Genesis Solar Energy Project - Docket Number 09-AFC-8

SUBJECT: Revisions to Jurisdictional Waters for the Genesis Solar Energy Project

Revisions to Jurisdictional Waters
Genesis Solar Energy Project
March 13, 2010

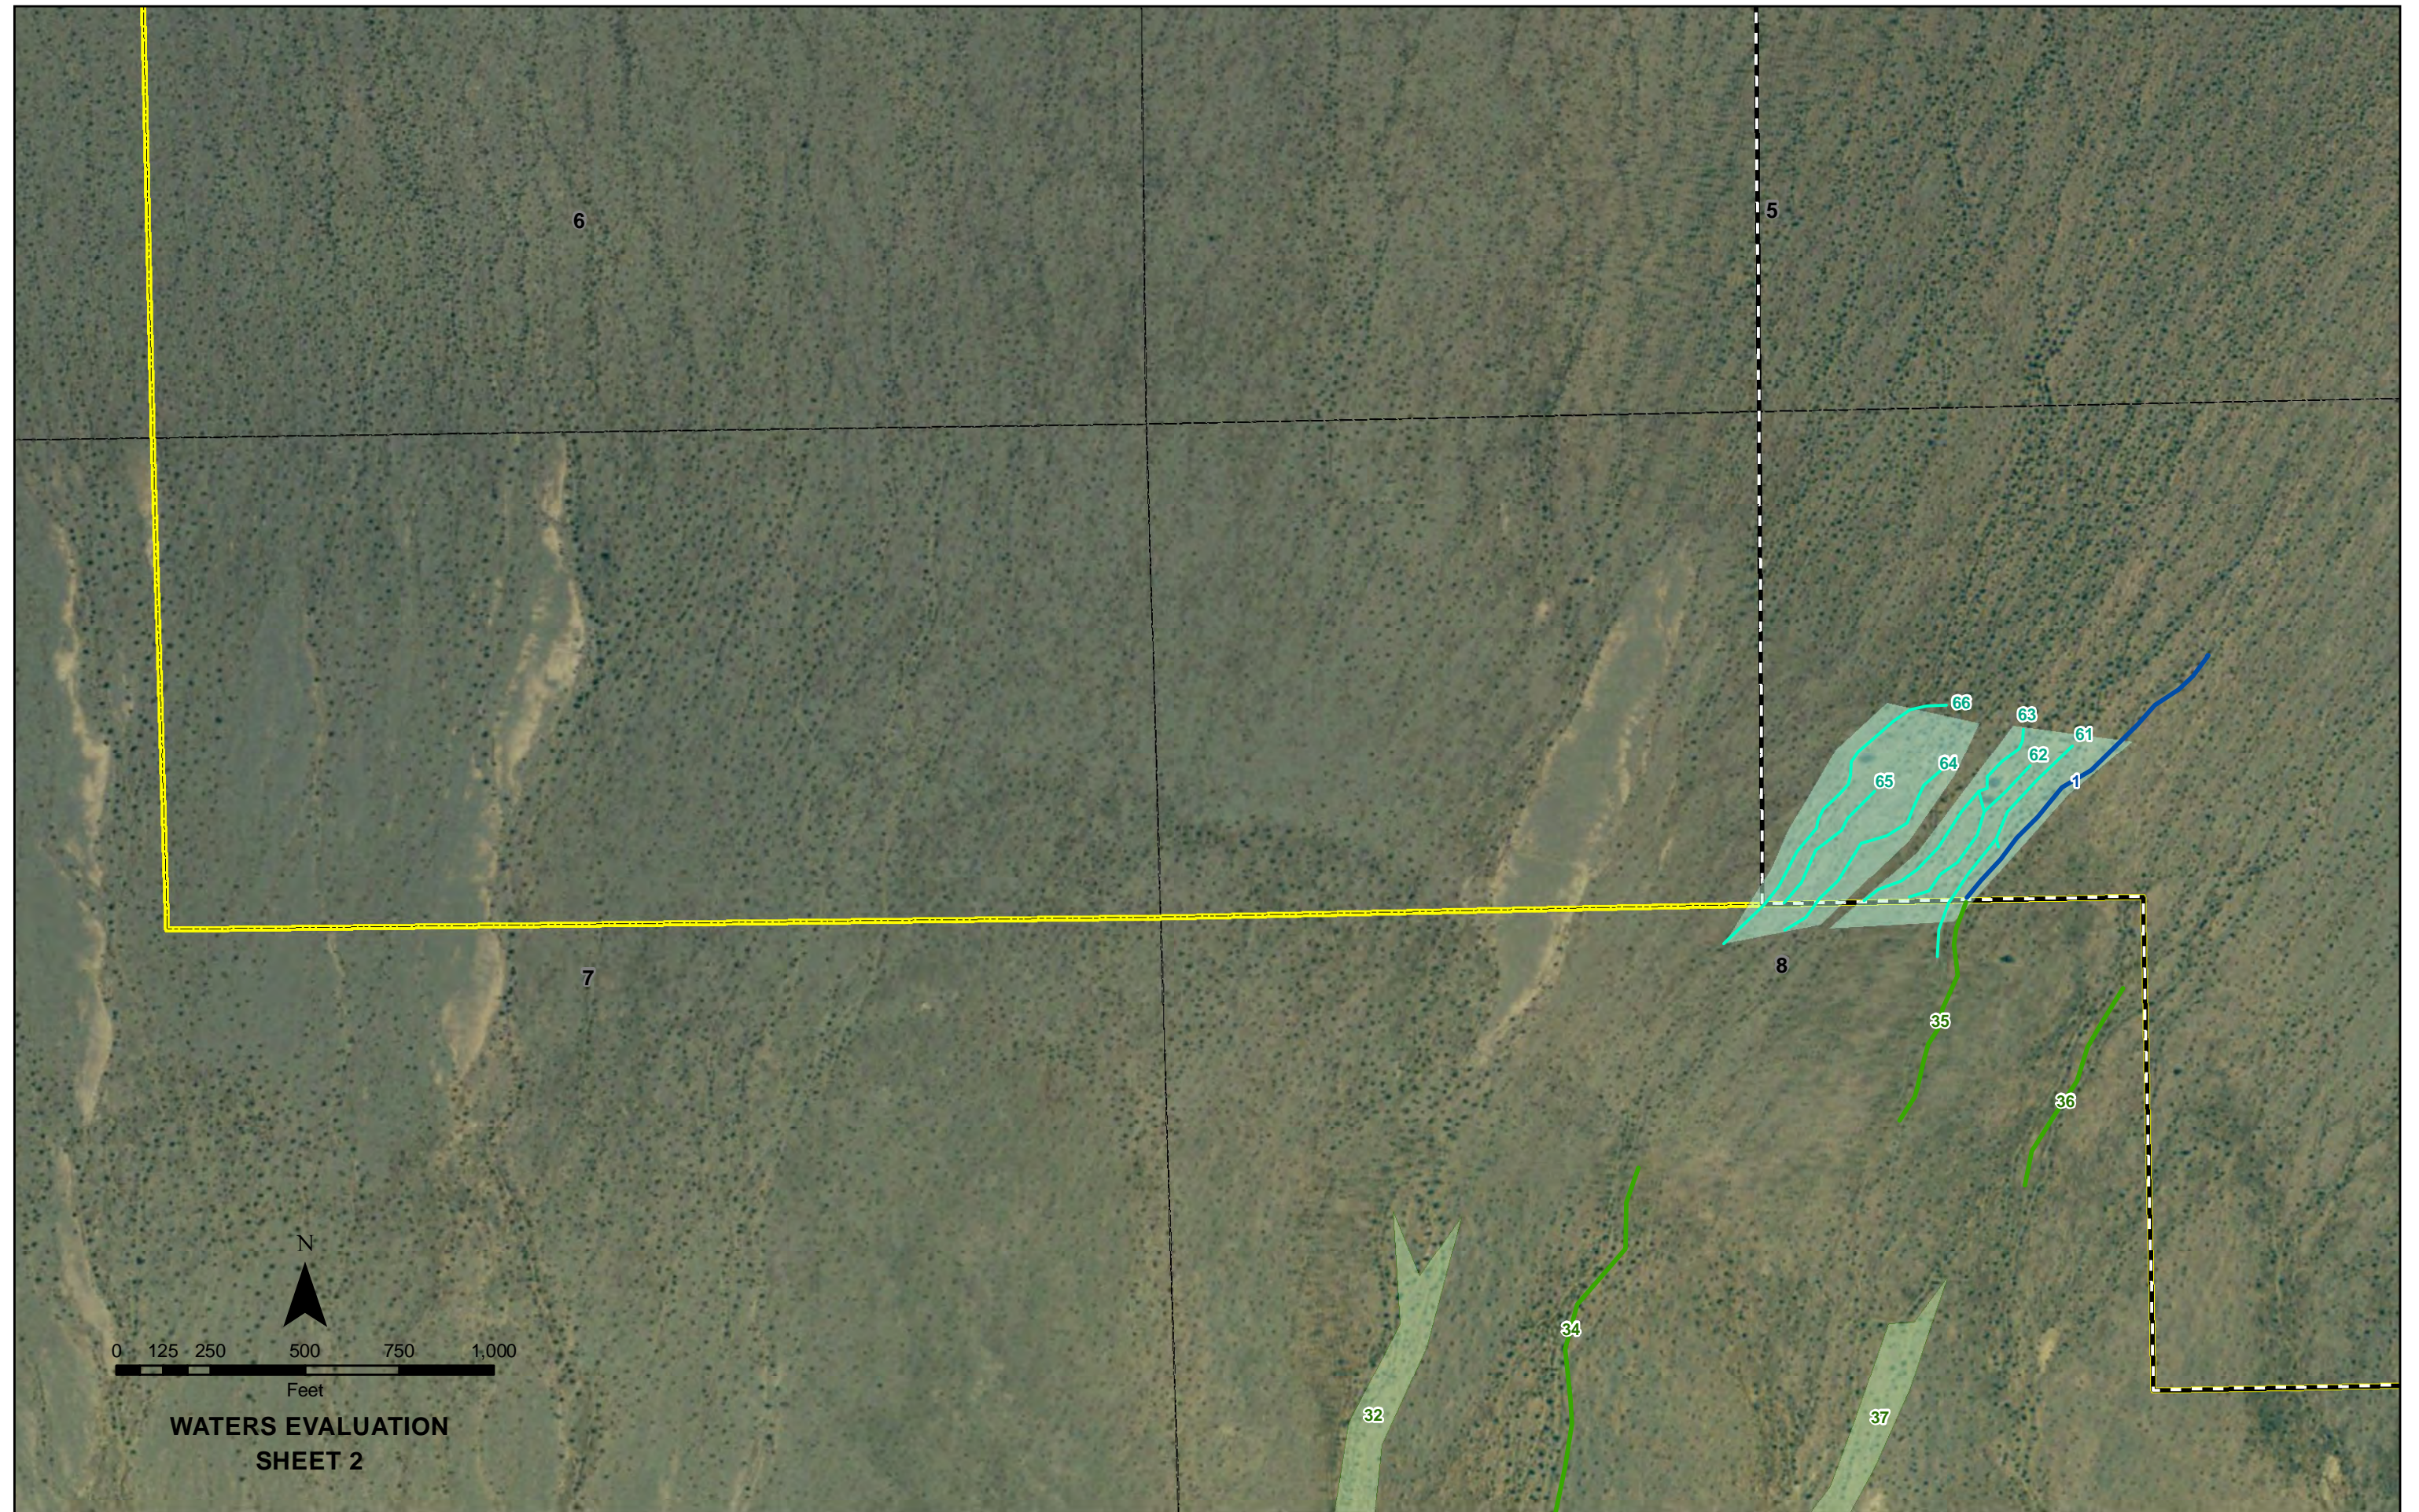
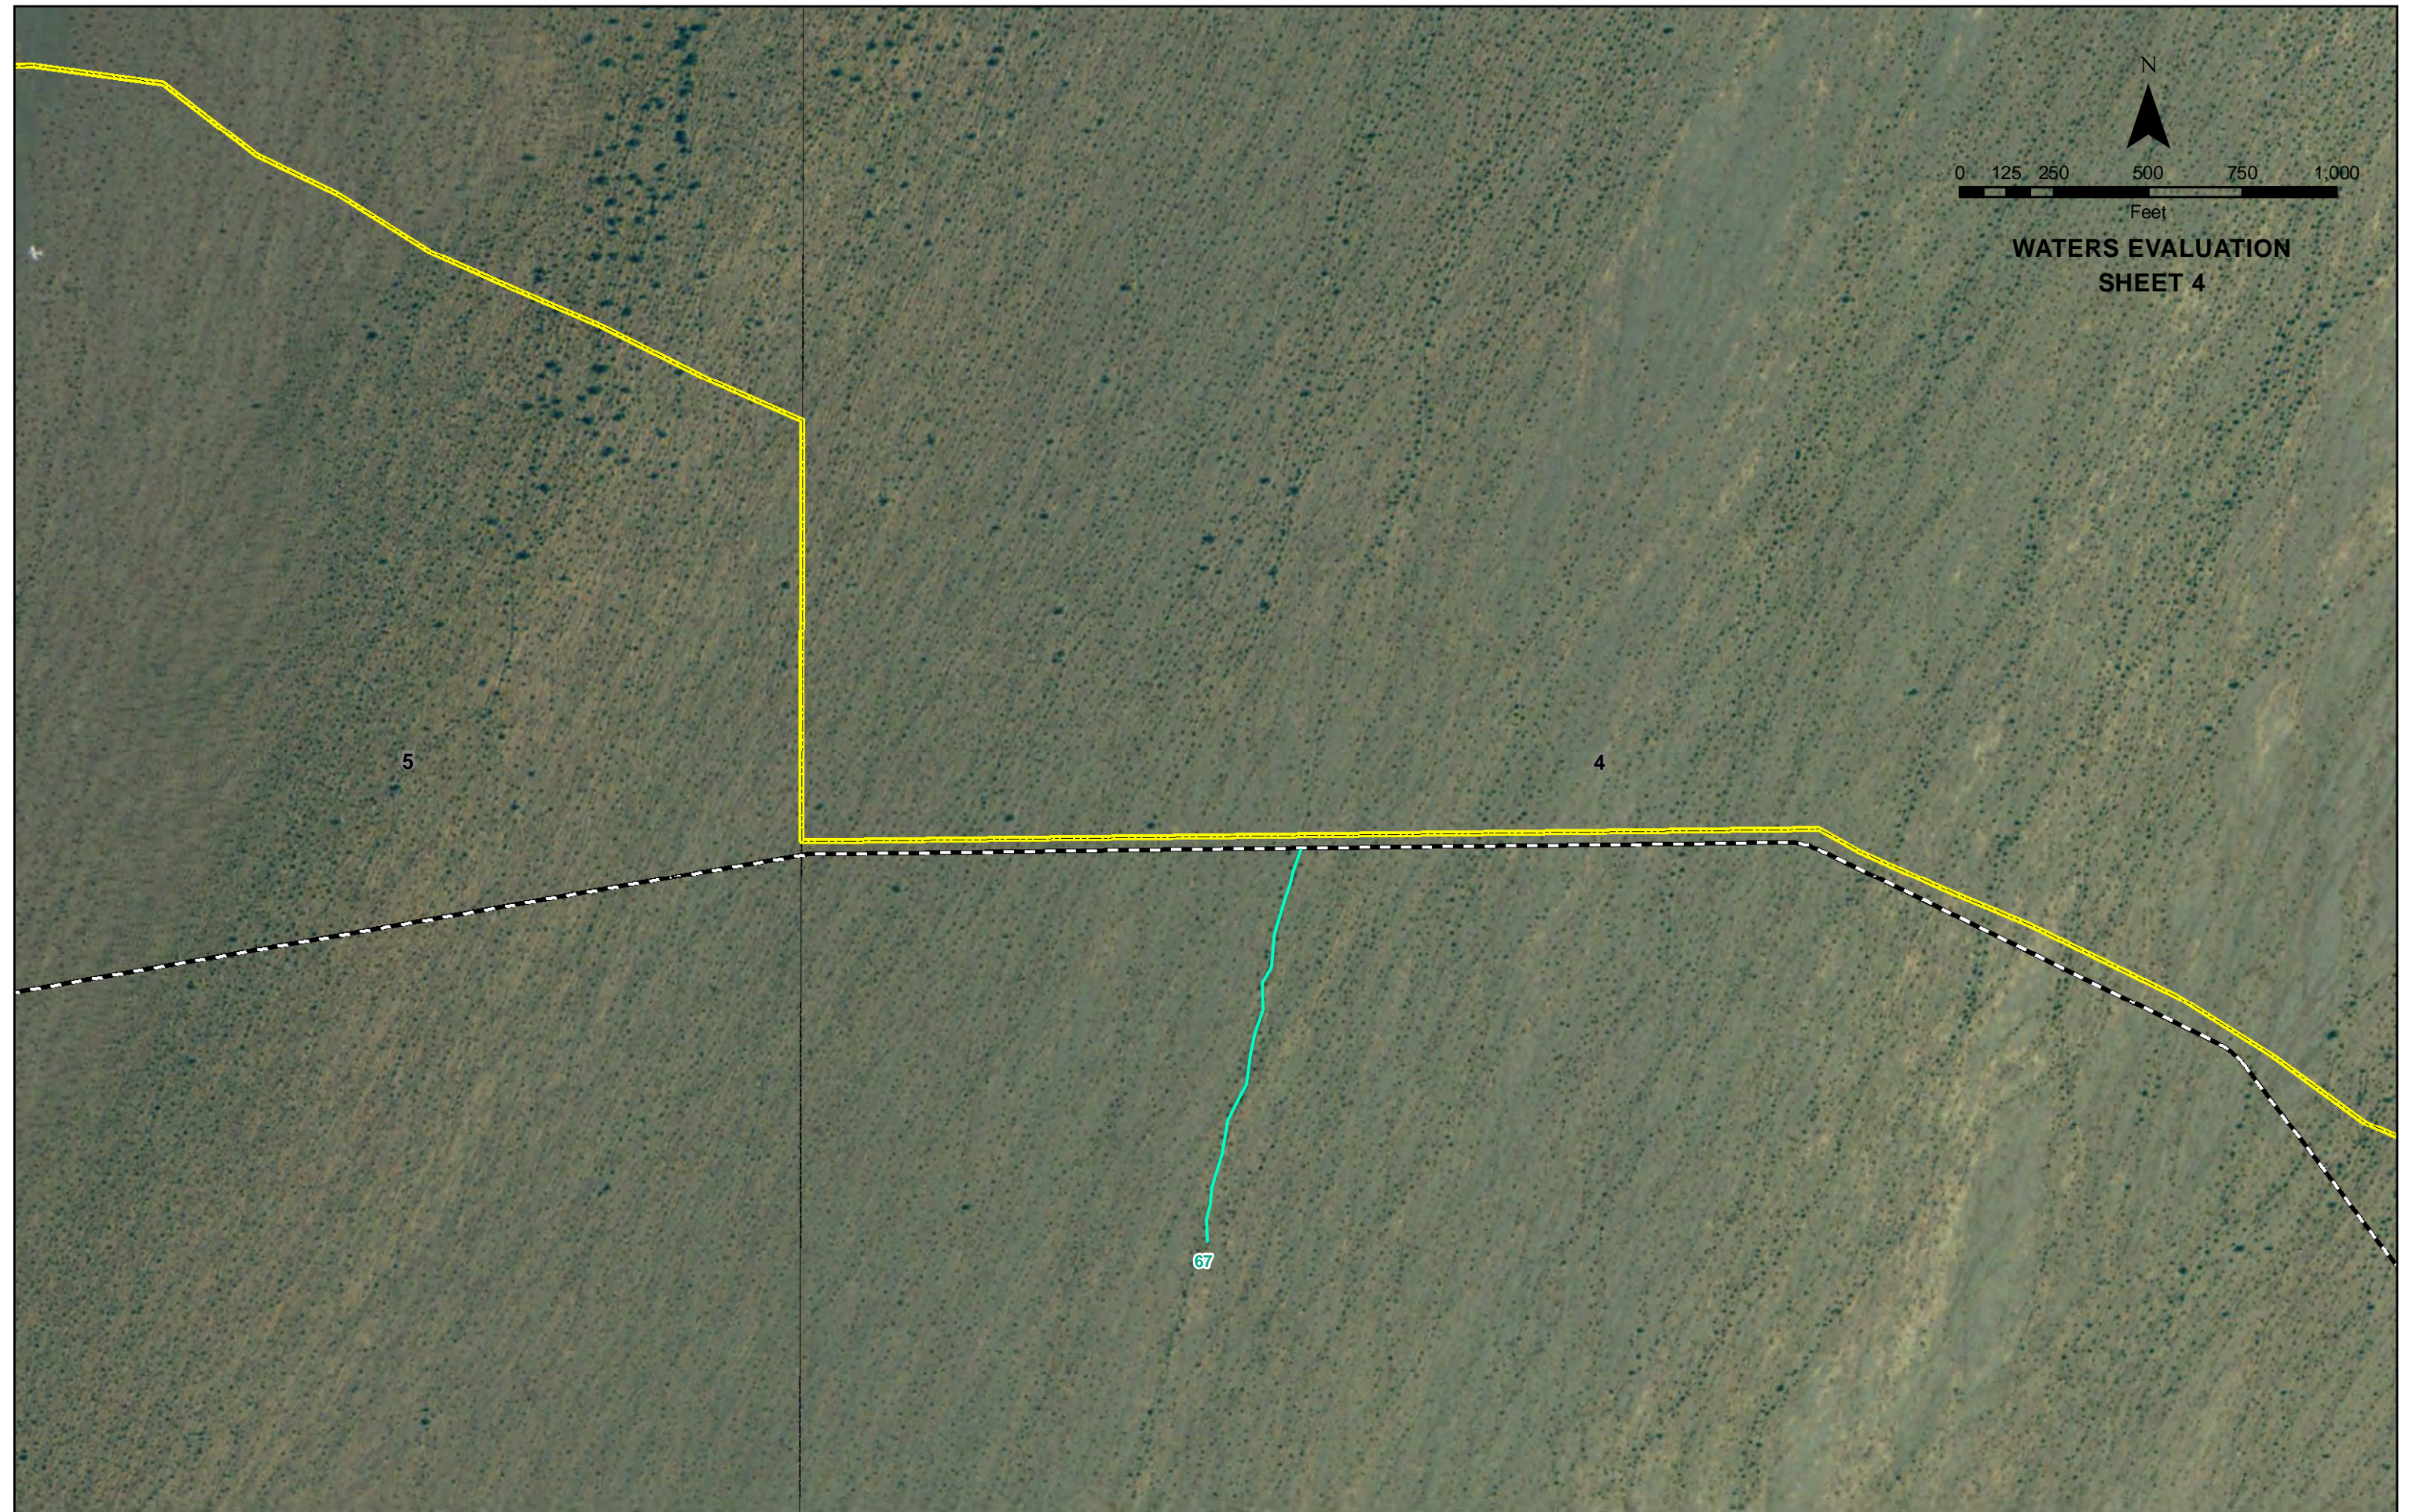
On February 17, 2010, you attended a field visit to the Genesis Solar Energy Project, primarily to evaluate tortoise habitat. During that site visit, you walked a portion of the Plant Site (project footprint) and took the opportunity to look at any water features (e.g., drainages, washes) you encountered. You evaluated a few of the delineated drainages in the *Jurisdictional Waters and Wetlands Report* for the Genesis Solar Energy Project (submitted in January 2010) to see if you agreed with the assessment. Additionally, you took note of water features that were not included in the report, but felt met the criteria for state waters, and should thus be included in the delineation report and impact calculations.

Genesis Solar, LLC (Genesis Solar) understands that your assessment is based only on the areas that you walked and that it is not a complete verification of the delineated drainages within the Project area. However, based on your field visit, you have determined that most of the western portion of the Plant Site is flat with low channels that exhibit a sheet flow pattern, as well as short narrow channels that come in and out of existence.

Per your request, Genesis Solar has revised the appropriate table and figures to depict the drainages you delineated in the field on February 17, 2010. Specifically, updates have been made to Appendix C. *Washes and Microphyllous Vegetation Directly Impacted by Project Facilities* and Map Sheets 2, 4, 5, 11, and 12 of the *Jurisdictional Waters and Wetlands Report* submitted in January 2010. The added drainages result in an additional 7.80 acres of permanent impact, 0.00 acres of temporary impact, 2 additional impacted trees (ironwood trees), and 0.00 acres of microphyll vegetation areas. The area permanently impacted by the Project is now 72.64 acres.
